NOTICE OF SPECIAL MEETING
CITY COUNCIL
OF THE CITY OF ATWATER

SUBJECT: **Approving Contract Change Orders to the General Construction Contract with Phase 1 Construction for the Fruitland Avenue Reconstruction – Phase 2 Project**

CONTRACT CHANGE ORDER NO. 3

PROJECT Fruitland Avenue Reconstruction Phase 2 **SHEET** 1 **OF** 5

Sheet No.
23 of 62 sheets

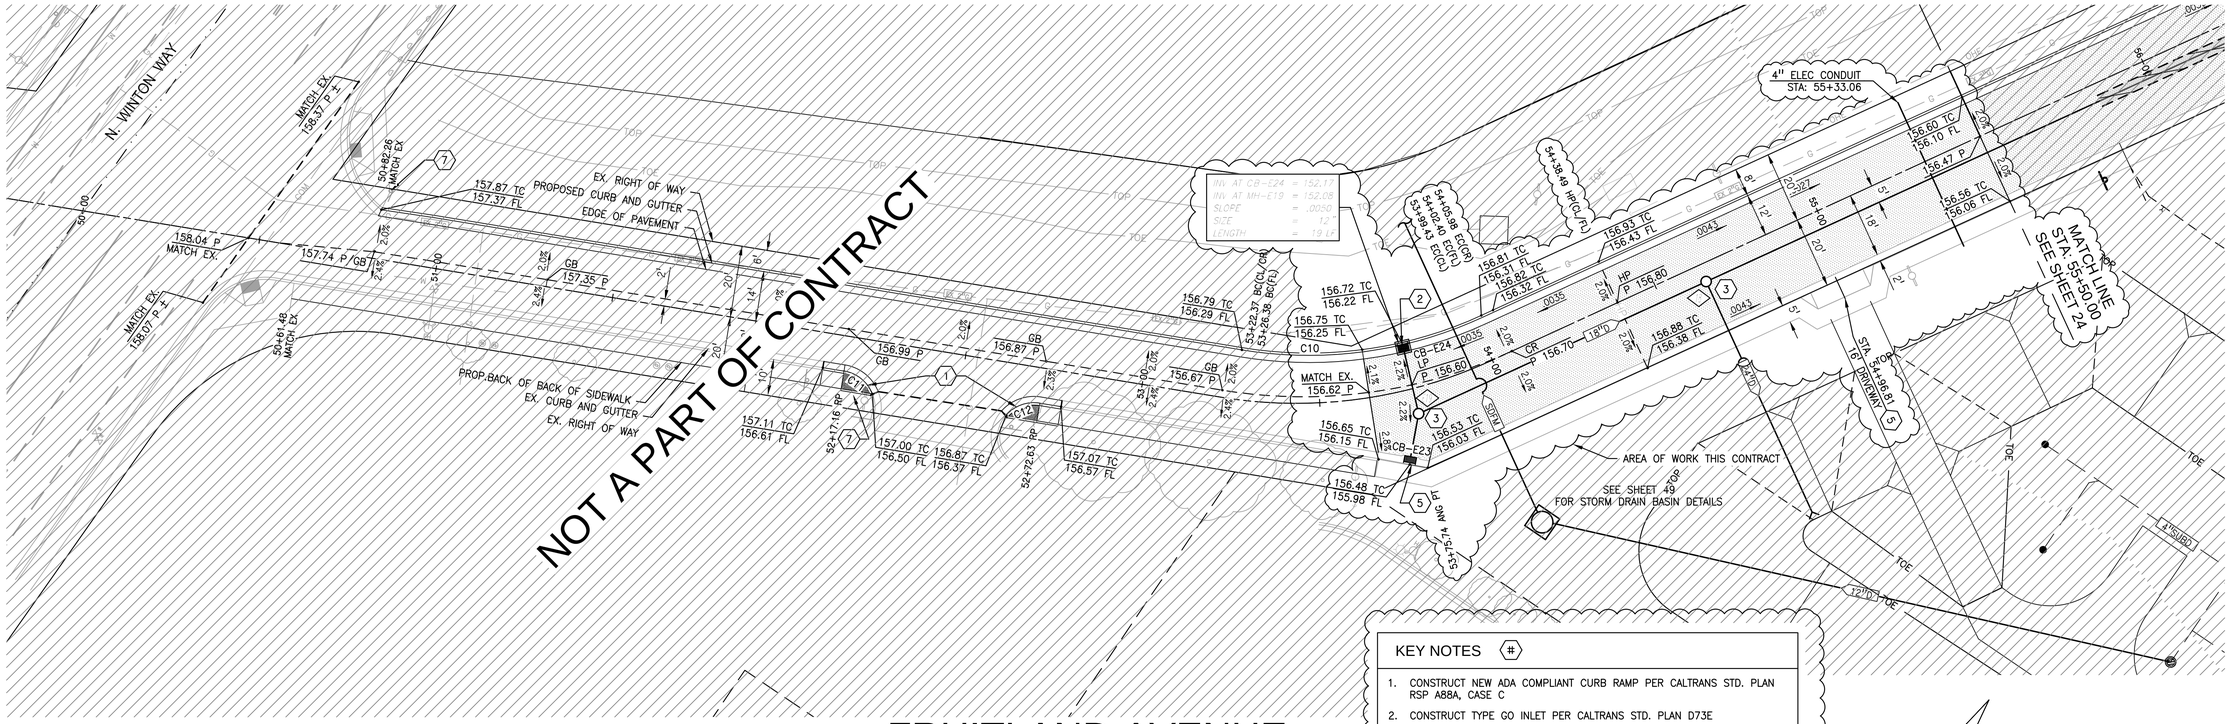
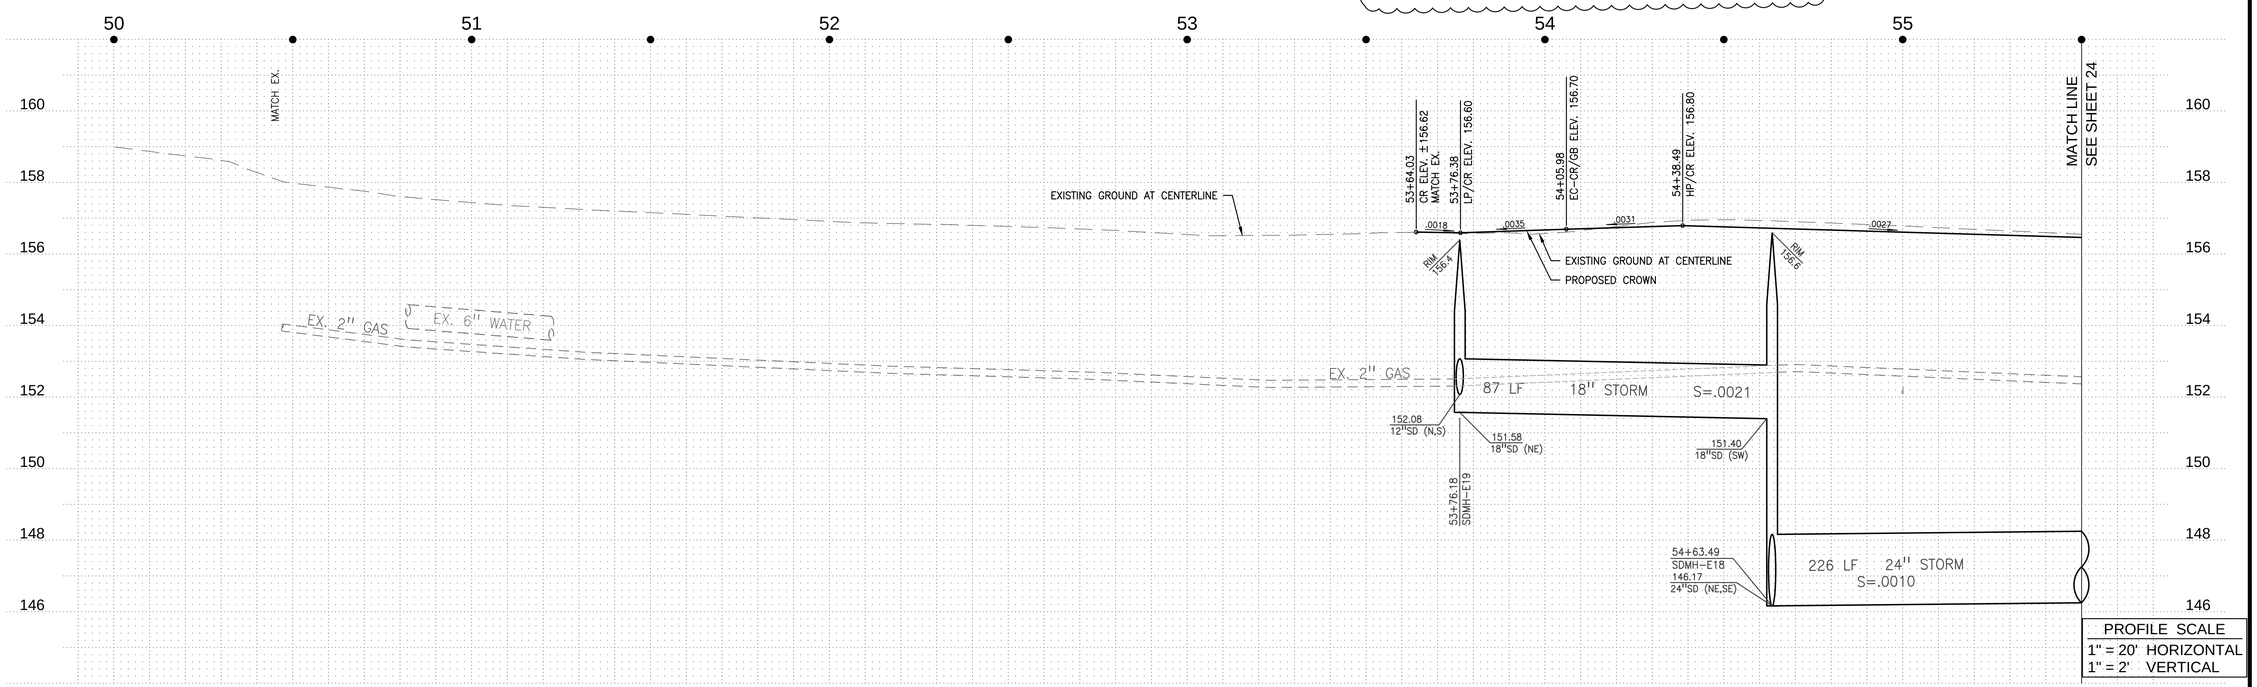
See revised improvement plan sheets 23, 24, and 26 attached and made a part of this Contract Change Order No. 3.

PAVEOUT WITH 3" HMA ON 6.5" AB ON NATIVE MATERIAL COMPACTED TO 95% R.D. ADJUST ALL EX. UTILITY STRUCTURE RIMS WITHIN PAVED AREA. COSTS FOR ADJUSTMENT OF RIMS TO GRADE IS TO BE INCLUDED IN UNIT COST OF HMA PAVEMENT.

Sheet No.
24 of 62 sheets

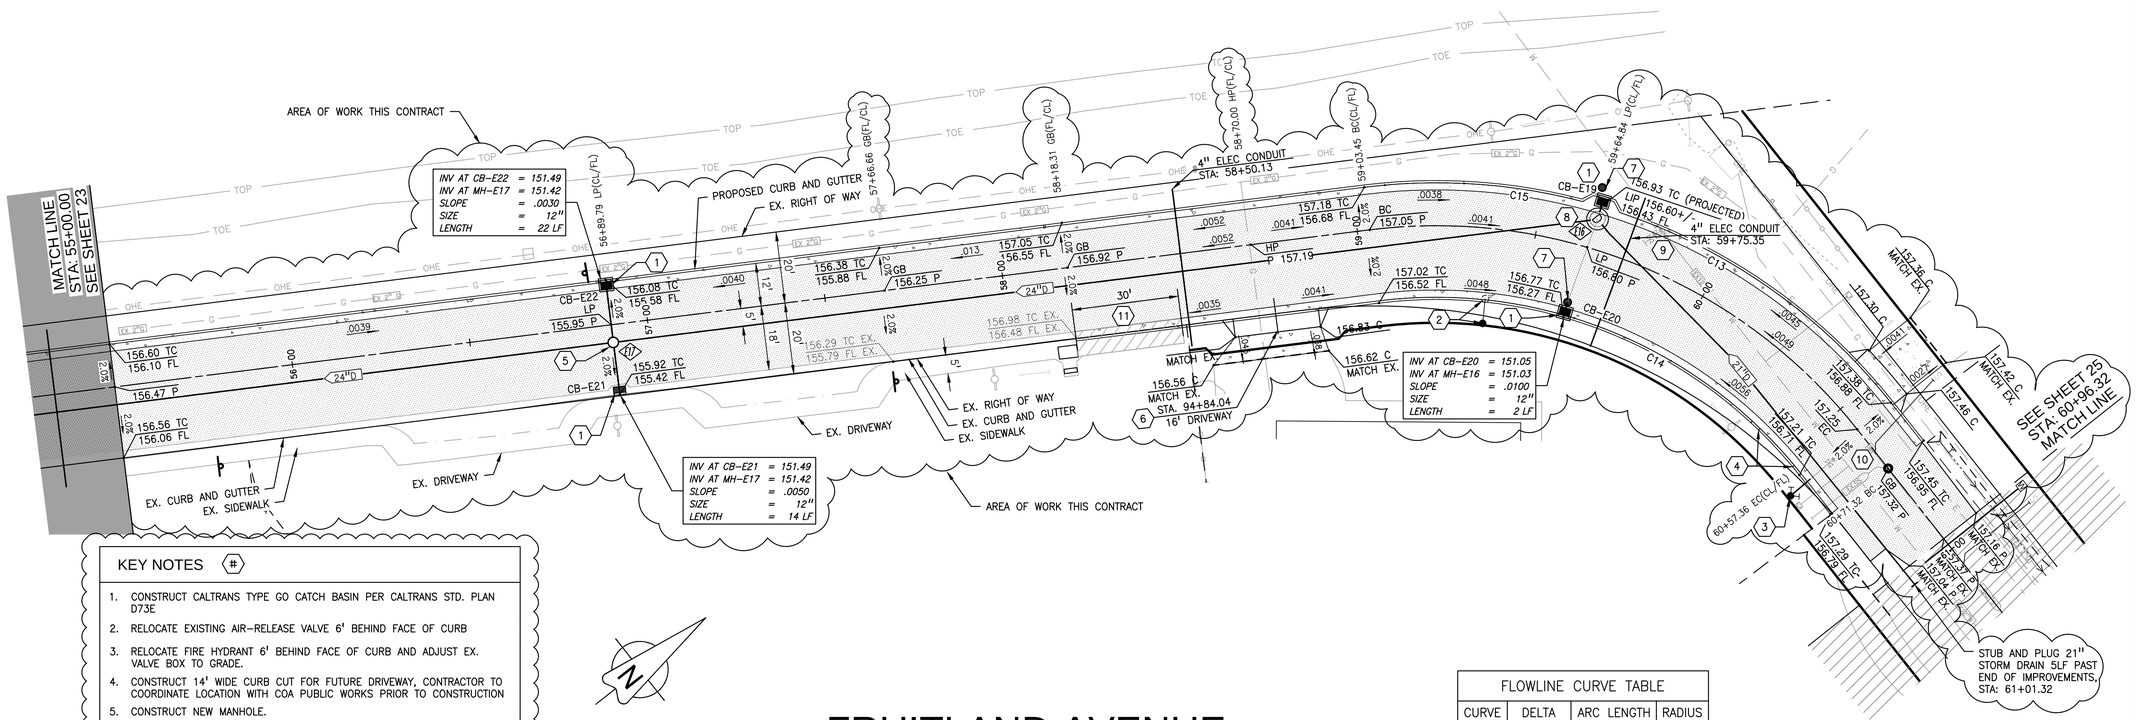
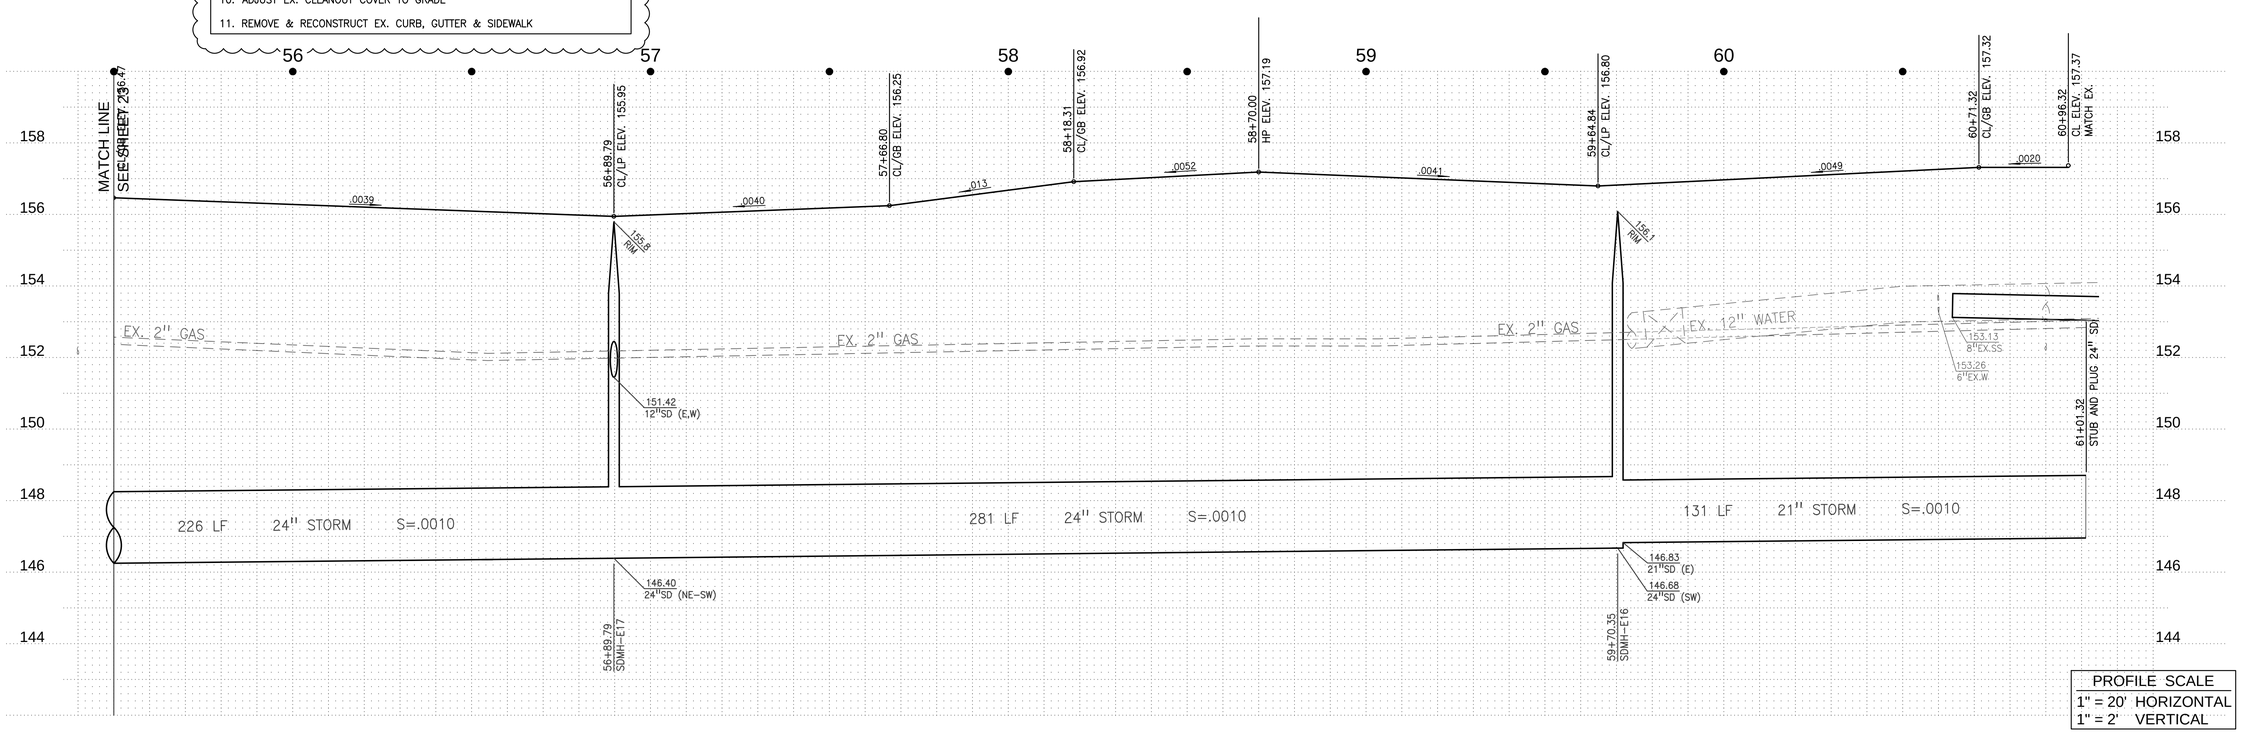
No.	Date	Revision	By	Appd.
1	04.22	ADDED SD LATERALS & CATCH BASIN	RFC
